AMENDMENTS TO THE DRAWINGS

REPLACEMENT DRAWING

Fig. 16

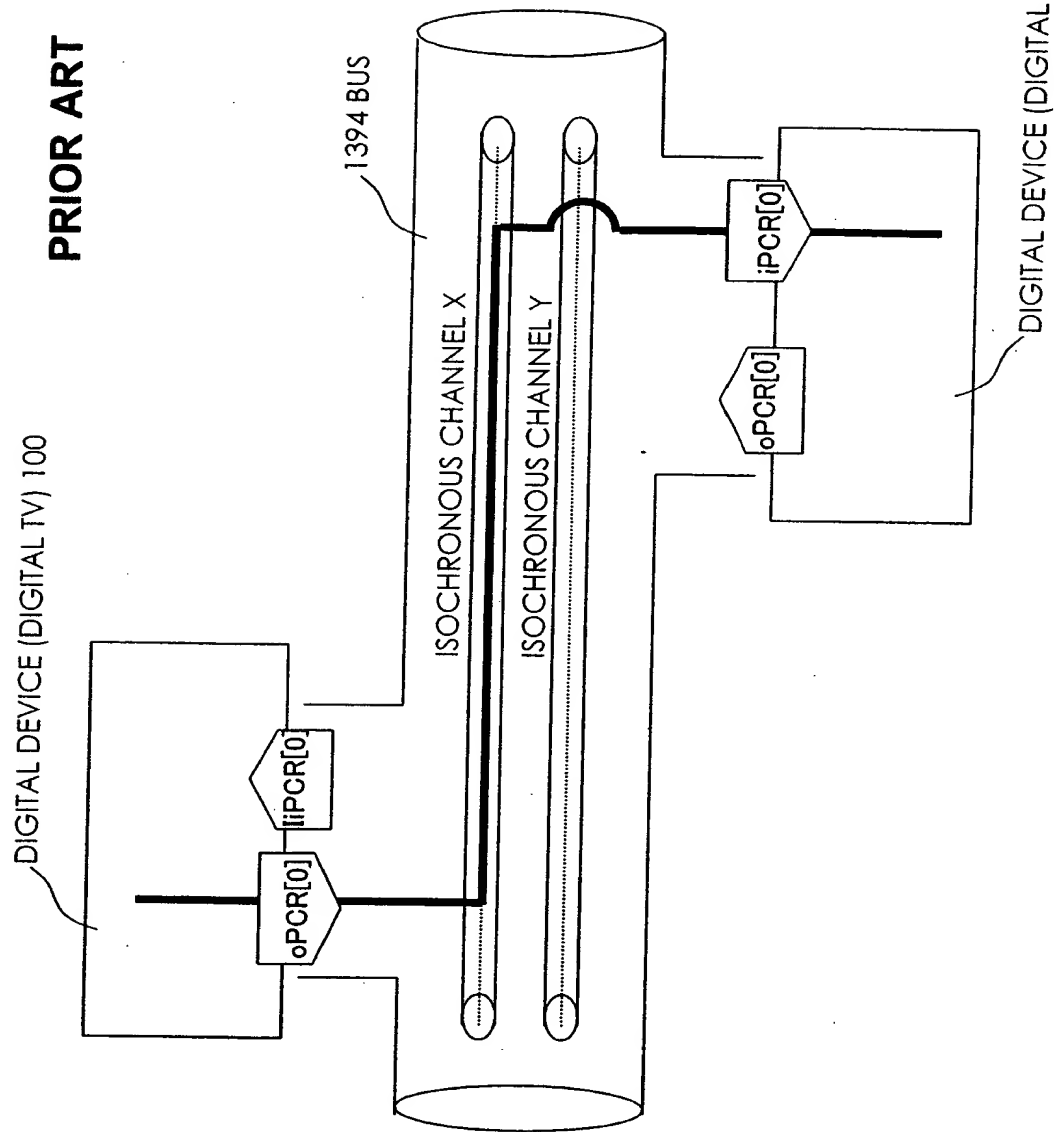
The attaches sheets of drawings include changes to Figs. 16-22. These sheets, which include Figs. 16-22, replace the original sheets including Figs. 16-22. The label "PRIOR ART" has been added to Figs. 16-22.

PRIOR ART

Fig. 17

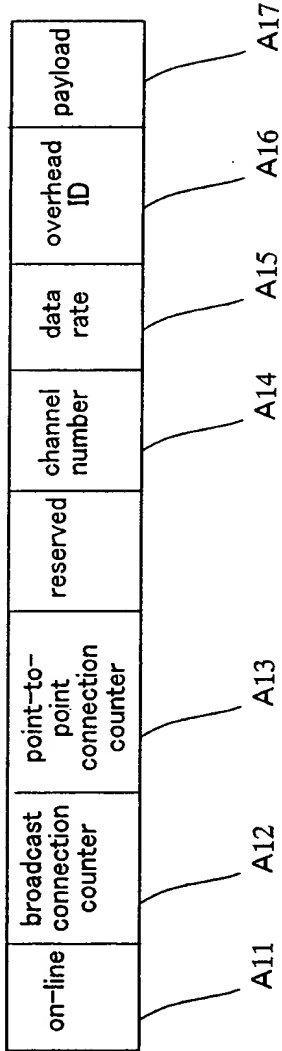
PRIOR ART

Fig. 18

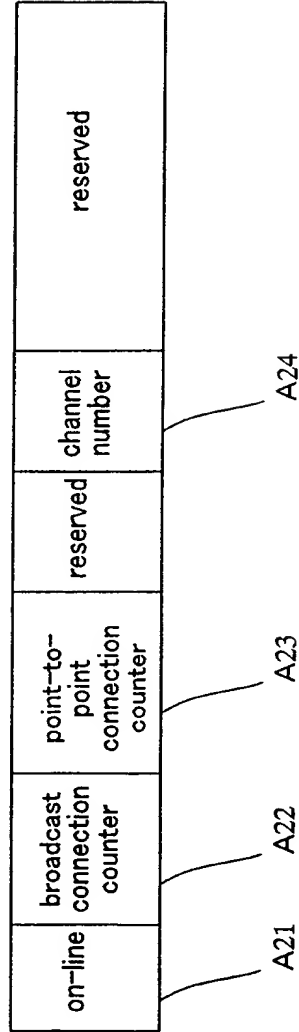
PRIOR ART

Fig. 19

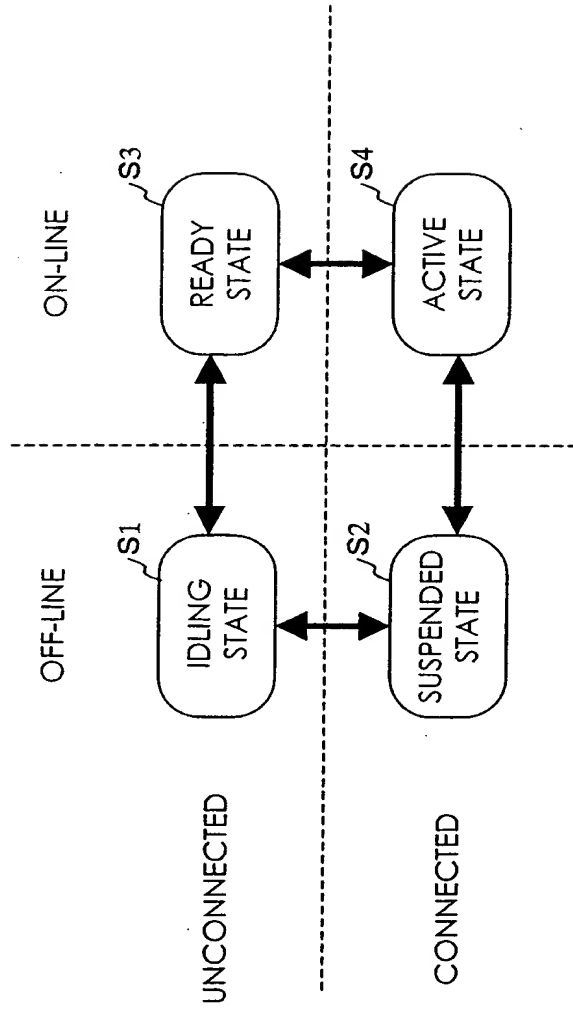
PRIOR ART

Fig. 20

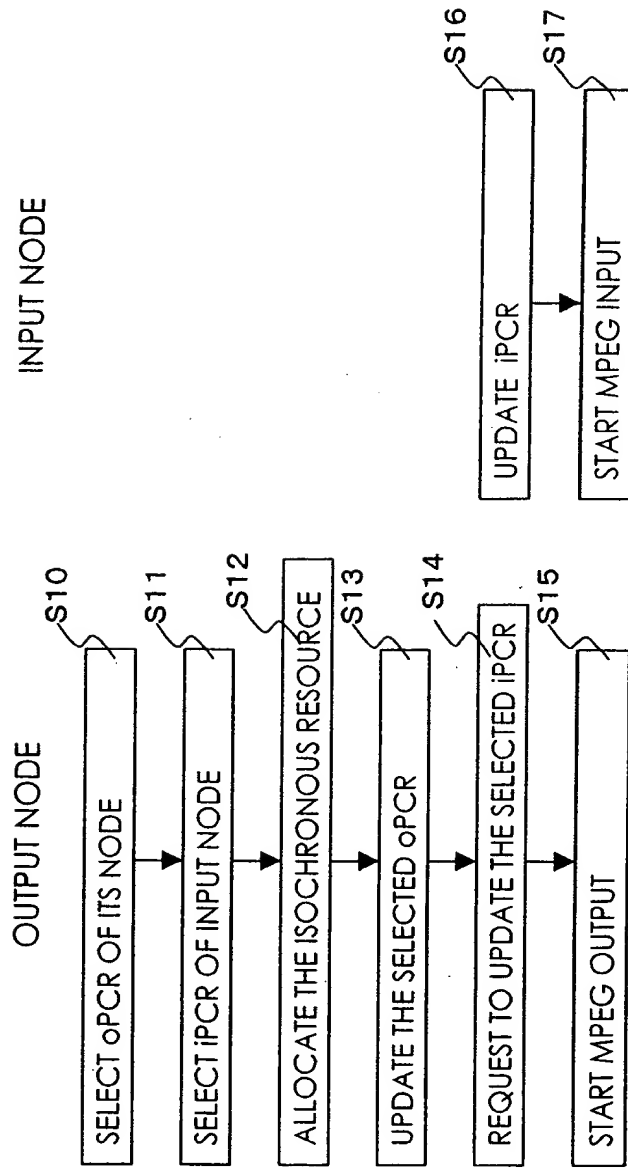
PRIOR ART

Fig. 21

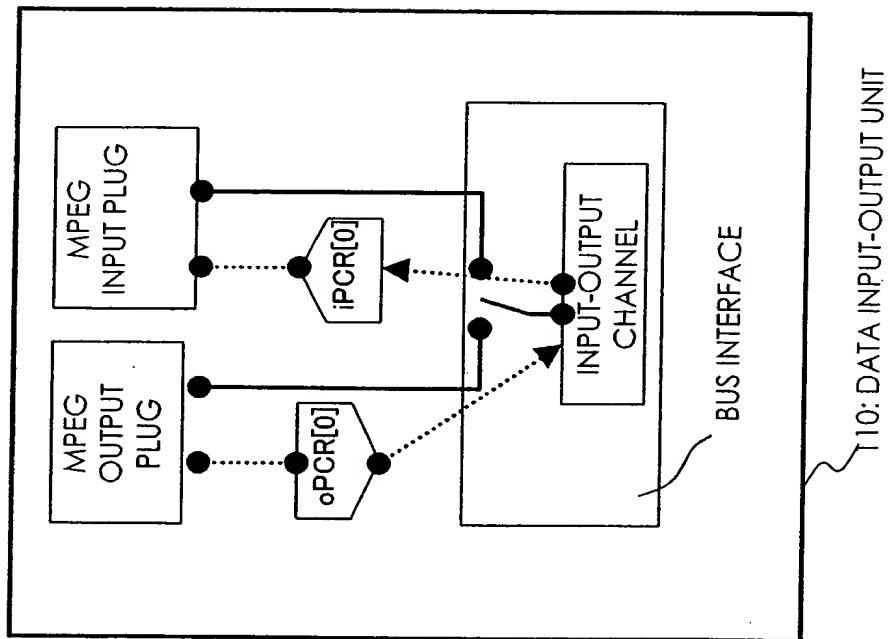
PRIOR ART

Fig.22

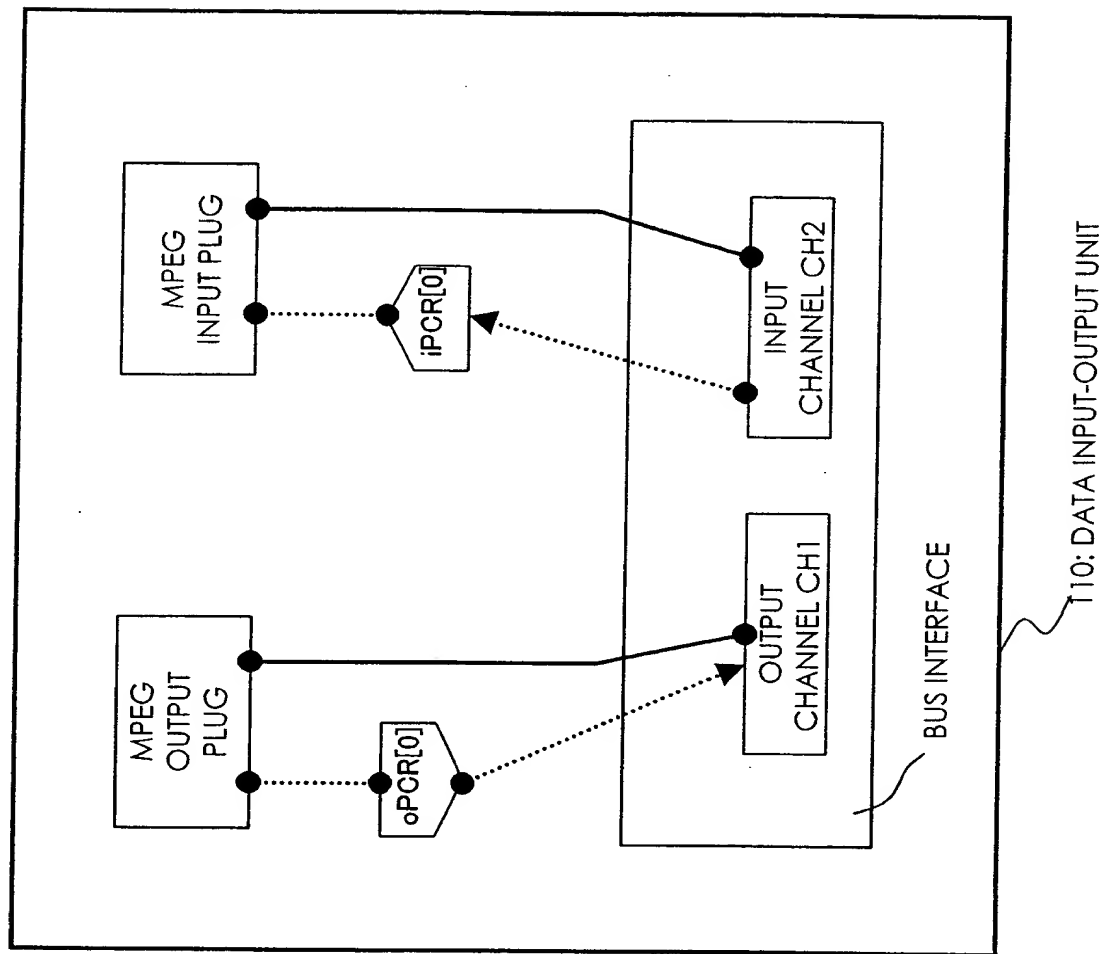
PRIOR ART
